HIGHWAY WORK PROPOSAL

<u>COUNTY</u>	<u>STATE PROJECT</u>	<u>FEDERAL</u>	<u>PROJECT DESCRIPTION</u>	<u>HIGHWAY</u>
Dane	5992-10-31	WISC 2019771	City Of Madison, Gammon Road; West Towne Mall To Grand Canyon Dr	LOC STR
Dane	5992-10-32	WISC 2019772	City Of Madison, Gammon Road; Ush 12 To Mineral Point Road	LOC STR
Dane	5992-10-33	N/A	City Of Madison, Gammon Road; Ush 12 To Mineral Point Road	LOC STR

ADDENDUM REQUIRED ATTACHED AT BACK

Addendum No. 01
ID 5992-10-31
Revised Sheet 524
November 19, 2019

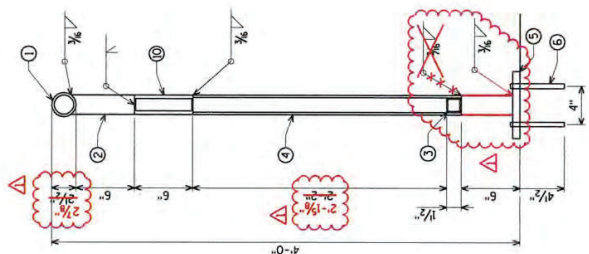
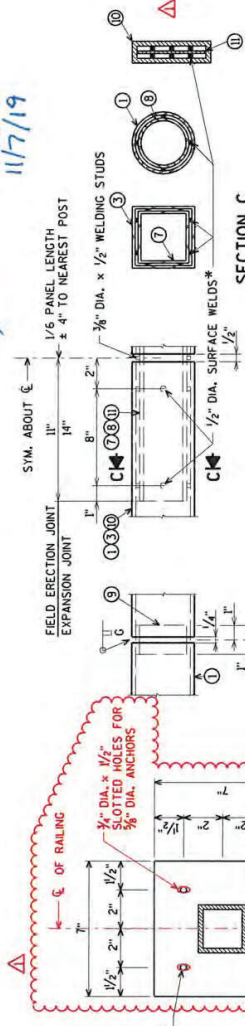
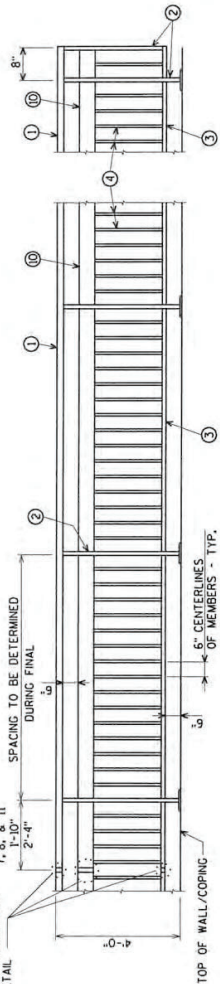
BID ITEM SHALL BE "RAILING STEEL R-13-338", WHICH INCLUDE ALL ITEMS SHOWN INCLUDING GALVANIZED COATING. RAILING SHALL BE FABRICATED IN 2 OR 3 PANEL LENGTHS. POST BASE PLATES NO. 5 SHALL BE FLAT WITH ALL SURFACES SMOOTH AND FREE FROM WARP AND ALL EDGES SMOOTH, STRAIGHT AND VERTICAL. ALL PLATE CUTS SHALL BE MACHINE OR MACHINE FLAME CUT. ALL MATERIAL EXCEPT ANCHOR BOLTS NO. 6 SHALL BE GALVANIZED AFTER FABRICATION.

Addendum No. 01
ID 5992-10-32
Revised Sheet 529
November 19, 2019

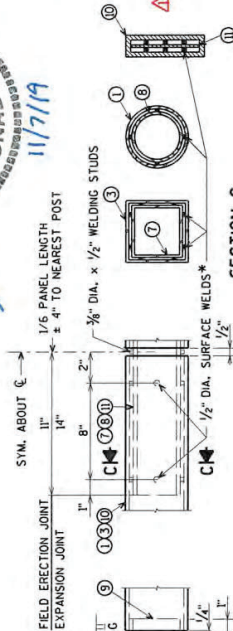
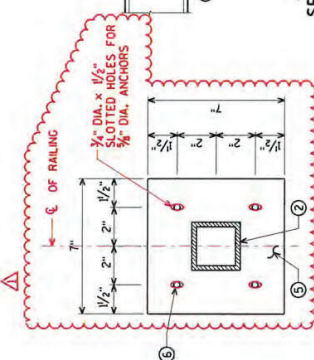
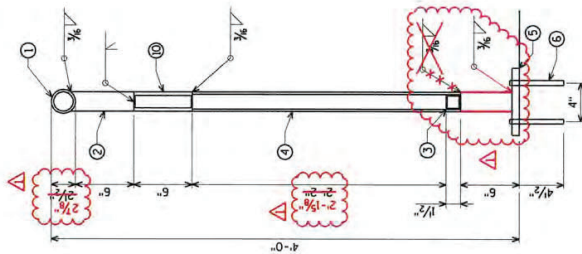
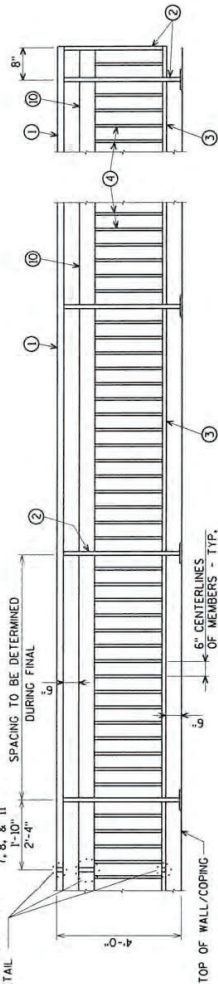
BID ITEM SHALL BE "RAILING STEEL R-13-339", WHICH INCLUDE ALL ITEMS SHOWN INCLUDING GALVANIZED COATING. RAILING SHALL BE FABRICATED IN 2 OR 3 PANEL LENGTHS. POST BASE PLATES NO. 5 SHALL BE FLAT WITH ALL SURFACES SMOOTH FREE FROM WARP AND ALL SURFACES SMOOTH. ALL SURFACES VERTICAL. ALL PLATE CUTS SHALL BE MACHINE OR MACHINE FLAME CUT. ALL MATERIAL EXCEPT ANCHOR BOLTS NO. 6 SHALL BE GALVANIZED AFTER FABRICATION.

PRIOR TO GALVANIZING ALL STEEL RAILING POSTS, STEEL TUBING, AND STEEL PIPE SHALL BE GIVEN A NO. 6 BLAST CLEANING PER S.S.P.C. SPECIFICATIONS.

Addendum No. 02
ID 5992-10-31/32/33
Revised Sheet 2
December 5, 2019

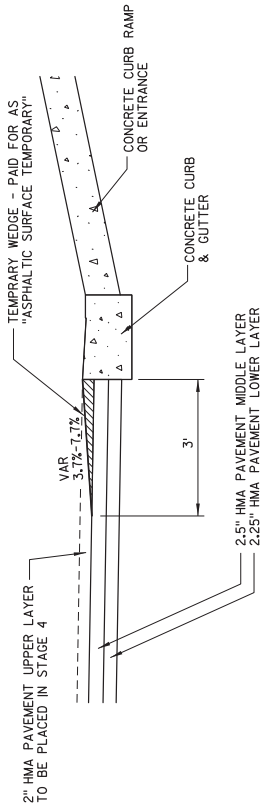
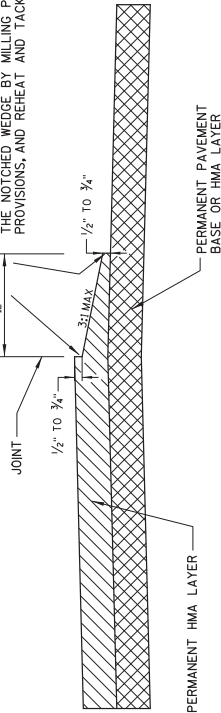
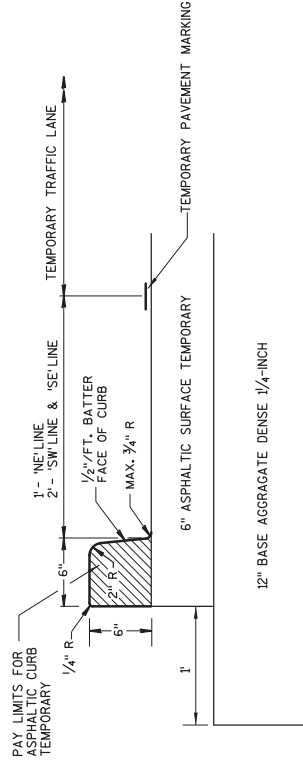
NOTES:
 PROVIDE ASPHALTIC WEDGES PRIOR TO
 OPENING PAVEMENT TO TRAFFIC.
 REMOVAL OF ASPHALTIC WEDGES WILL BE
 PAID FOR AS "REMOVING ASPHALTIC SURFACE
 BUTT JOINTS."

PROVIDE TEMPORARY NOTCHED WEDGE FOR HMA JOINTS
 HAVING A DROP OF 2" OR MORE, AND UNDER TRAFFIC.
 BEFORE CONTINUATION OF PERMANENT PAVING, REMOVE
 THE NOTCHED WEDGE BY MILLING PER THE SPECIAL
 PROVISIONS, AND REPEAT AND TACK THE JOINT.
